To: All Proponents
From: Bryan Avery, Security/Operations and Service Development Manager
CC: Jack Santerre, Airport Manager
Date: November 1, 2017
Re: Addendum # 1 to the RFP for Remove and Replace of Existing Carpet and Vinyl Tile In the Administration Building at the North Bay Jack Garland Airport

Addendum #1

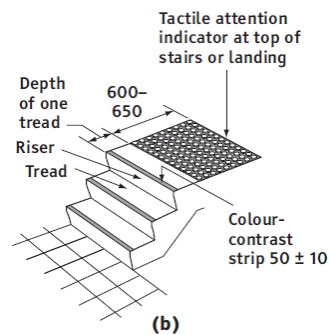
- For the each landing at the stairs and the ramp provide a one piece raised circular design or equivalent to produce a tactile attention indicator, as per CSA B651-12 (colour to be determined after contract awarded and to be a contrast with the adjacent flooring). The depth of the new tactile attention indicator will match the depths of the current surfaces, which in all cases exceeds the CSA requirements.
